CARLINGFORD PUBLIC REALM SCHEME

Stage 1 Road Safety Audit

MGT0610Rp1010
Carlingford Public Realm Scheme
S4_P01
13 April 2023

STAGE 1 ROAD SAFETY AUDIT

Problem 4.6

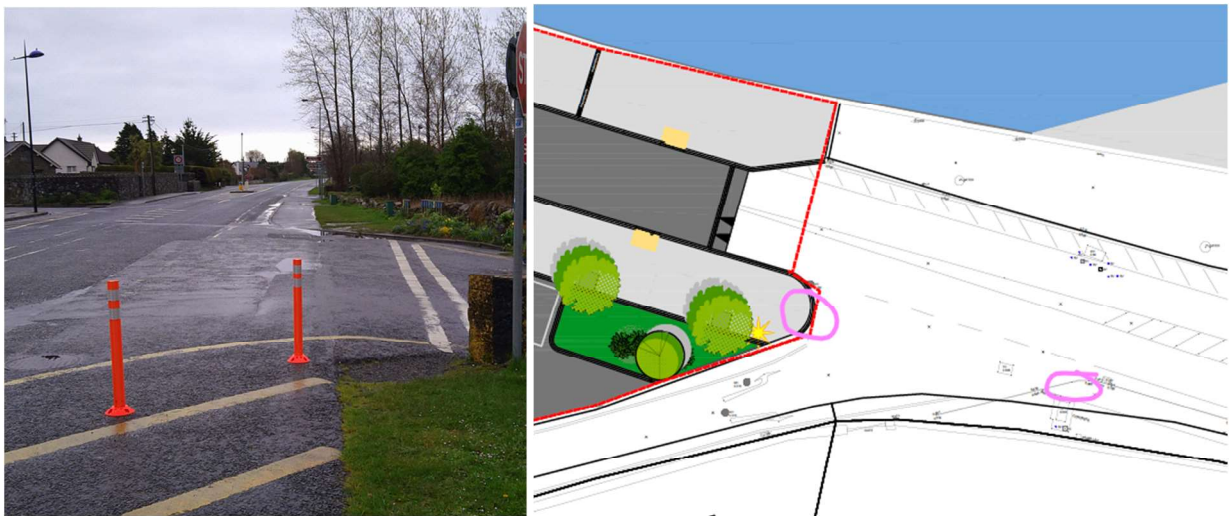
Summary & Location – Widened R173 Carriageway outside Tourist Office

The R173 carriageway outside the Tourist Office and proposed park widens out, and it is unclear from the design what purpose of this is for. This could give rise to unwarranted parking or stopping/pulling in, which could give rise to side-swipe or rear-end collisions on the carriageway.

Definition of the carriageway width and its purposes should be clear, and preventative to unwarranted parking or pulling in.

4.6	Yes	Yes	To the north, the existing bus stop arrangement is being retained and to the south of this, the existing on street parking is being retained. Road markings will be added at detailed design to give clear indication of this

Problem 4.8

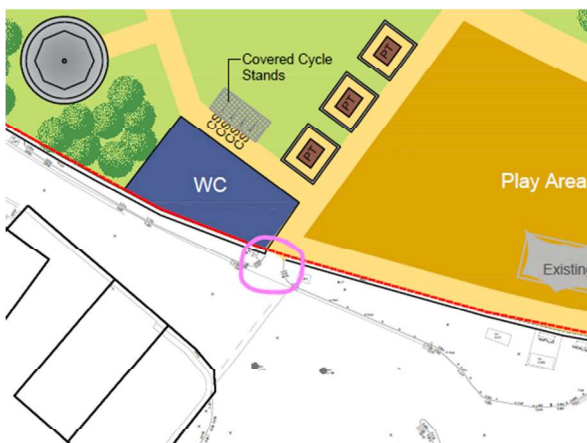
Summary & Location – Lack of Pedestrian Access from PR Car Park to the Park & Footpaths

It appears from the drawings that no pedestrian access or dropped kerbs are being provided from the PR car park to the Park or the adjacent footpaths. This could result in pedestrians, and in particular mobility impaired pedestrians, using the vehicular entrance, and coming into conflict with vehicular traffic.

Suitable pedestrian and mobility impaired access facilities should be provided from the car park to the Park and footpaths.

4.8	Yes	Yes	<i>Dropped kerbs will be shown clearly at detailed design stage</i>	Alternative measures or reasons accepted by Auditors (Yes/No)
4.9	Yes	Yes	<i>This is outside of the Works area. LCC to be informed of recommended measures</i>

Problem 4.10

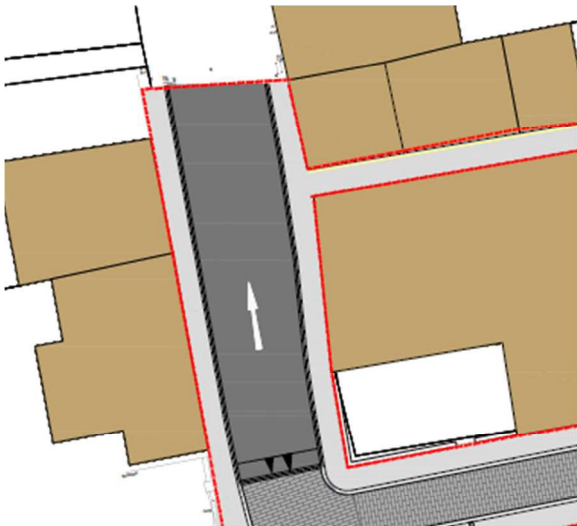
Summary & Location – Prevention of Vehicles entering Pedestrian Areas of PR area.

According to the drawings, the level of the carriageway and the footpath on the section below are flush – no vertical segregation. During the site visit, quite a number of cars were observed entering the village along this street. It is unclear what definition or measures will be provided to prevent vehicles encroaching on pedestrian areas, and in particular, to prevent vehicles entering the PR area to the north or the Park area to the south behind the Tourist Office and potential unwarranted parking. This could result in conflicts between vehicles and pedestrians.

Clear definition should be provided to highlight the areas that vehicles can utilise, and prevention measures should be put in place to prevent unwarranted vehicular access to pedestrianised areas.

4.10	Yes	Yes	<i>Shared surface will be constructed as per DMURS guidance. Bollards will be provided to prevent unwarranted parking</i>	
4.11	Yes	Yes	<i>Current arrangement is being retained and repaved. No reported issues at this location. LCC to be notified of problem with regards the outdoor dining area</i>

Problem 4.11

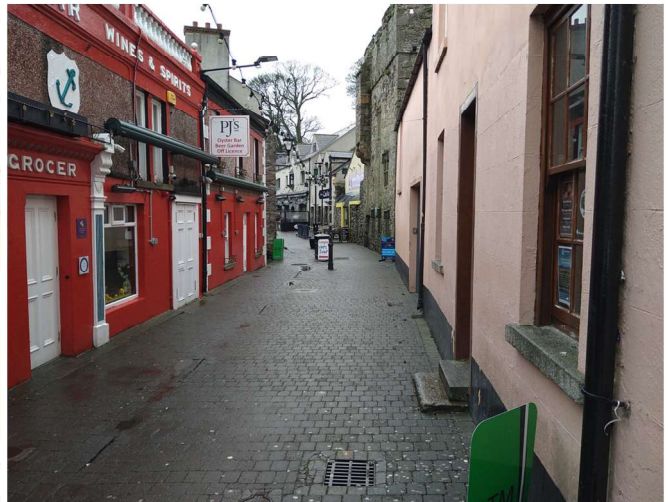
Summary & Location – Potential Insufficient Width for all users on Newry Street

It is unclear from the drawings if the outdoor dining area on street is being retained or removed, or if the on-street parking opposite is being retained or removed. Keeping both could result in a lack of sufficient width for all road users, giving rise to potential side-swipe collisions.

Appropriate width for all street elements should be provided.

Problem 4.13

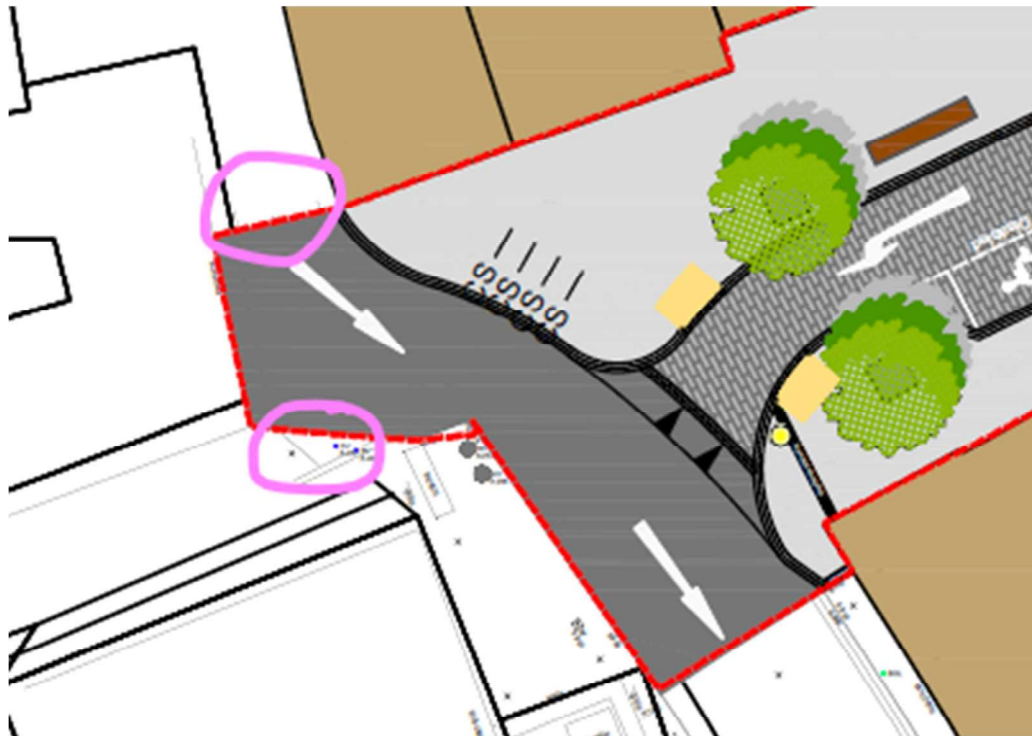
Summary & Location – Effective Footpath Width on Market St. due to Lighting Column

It is unclear from the drawings if the existing public lighting columns are being retained or removed/relocated. At this location on Market St. there would appear to be insufficient width for mobility-impaired pedestrians to negotiate around the existing lighting column. This could result in pedestrians entering the carriageway, and coming into conflict with traffic.

Ensure suitable footpath width for all pedestrian users is provided.

4.12	Yes	Yes	<i>Shared surface will be constructed as per DMURS guidance. Bollards will be provided to prevent unwarranted vehicular access</i>	
4.13	Yes	Yes	<i>Public lighting will be redesigned at detailed design stage and positioned appropriately</i>

Problem 4.16

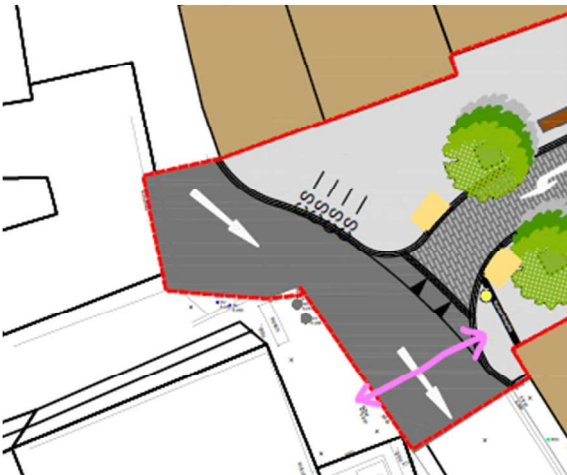
Summary & Location – No Provision of Dropped Kerb access for Pedestrians from Back Lane.

There is an existing dropped kerb and pedestrian access at the corner of the junction near Back Lane. The design drawings propose to remove this, meaning that any pedestrians, in particular mobility impaired pedestrians coming from Back Lane, will have to travel on the carriageway and into Market St carriageway in order to access the footpaths.

Provide appropriate access to footpaths for all pedestrian types from Back Lane/River Lane

4.15	Yes	Yes	<i>Road markings will be added at detailed design to give clear indication of priority.</i>	
4.16	Yes	Yes	<i>Tactile paving and dropped kerbs to be included in detailed design</i>

Problem 4.18

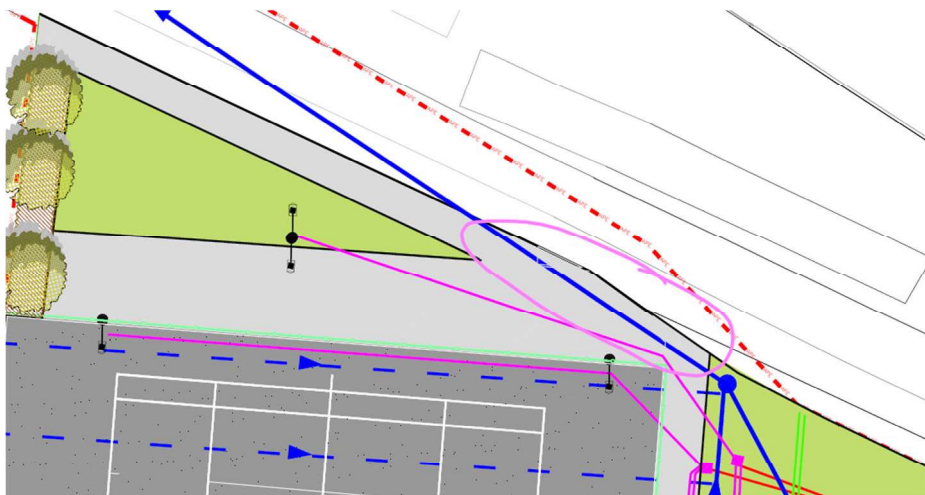
Summary & Location – No pedestrian demarcation on western aisle of Southern Car Park

Pedestrian pathways have been demarcated in the proposed design for 2 of the 3 aisles in the Southern Car Park, yet none have been provided in the western aisle. A lack of consistency and segregation on this aisle could give rise to collisions between pedestrians and vehicles.

Provide pedestrian demarcated pathway on western aisle also.

Problem No. in Report	To be Completed by Designer		Describe alternative measure(s). Give reasons for not accepting recommended measure	To be Completed by Audit Team Leader
	Problem accepted (Yes/No)	Recommended measure accepted (Yes/No)		
4.18	No	No	<i>Pedestrian pathways have been included on sections where traffic flow is one way and therefore sufficient space is available to provide. The area described in this problem is a two-way traffic flow and therefore cannot be provided</i>	Alternative measures or reasons accepted by Auditors (Yes/No) Yes (Delineation arrows should be provided in order to define traffic flow directions on all aisles)
4.19	Yes	Yes	<i>Dropped kerbs will be provided at detailed design</i>

Problem 4.19

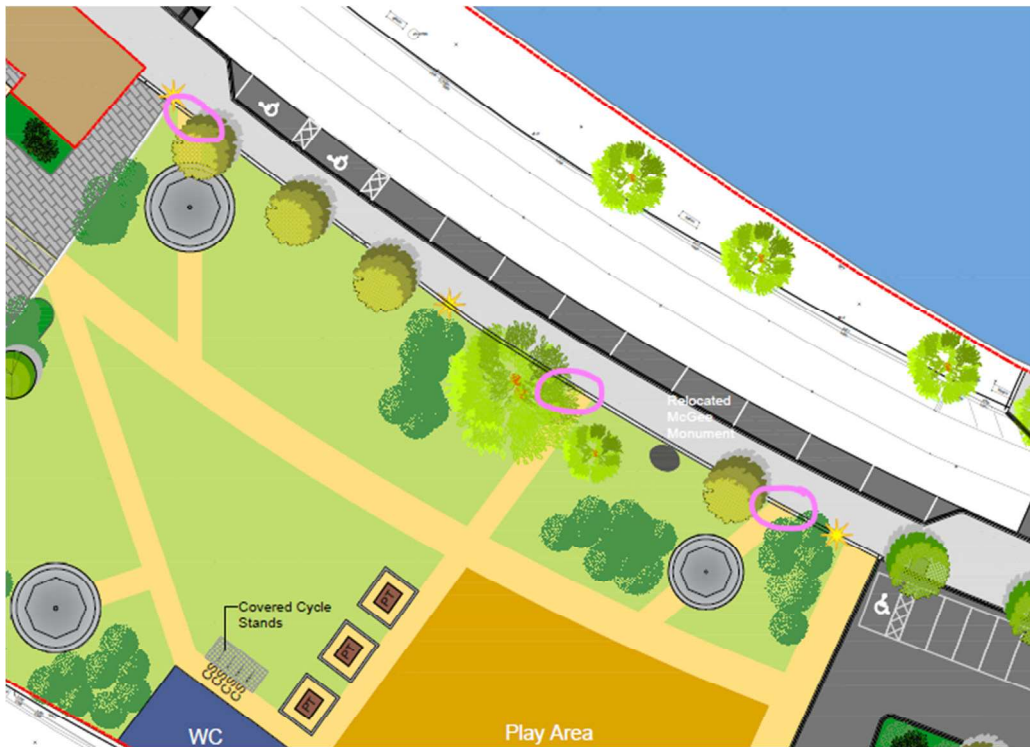
Summary & Location – No dropped kerb access for pedestrians from Ghan Rd to back entrance.

It is unclear if dropped kerb access has been provided for pedestrians entering the tennis courts and back entrance to the Southern Car Park. This could give rise to pedestrian falls.

Provide dropped kerb access for pedestrians from Ghan Road.
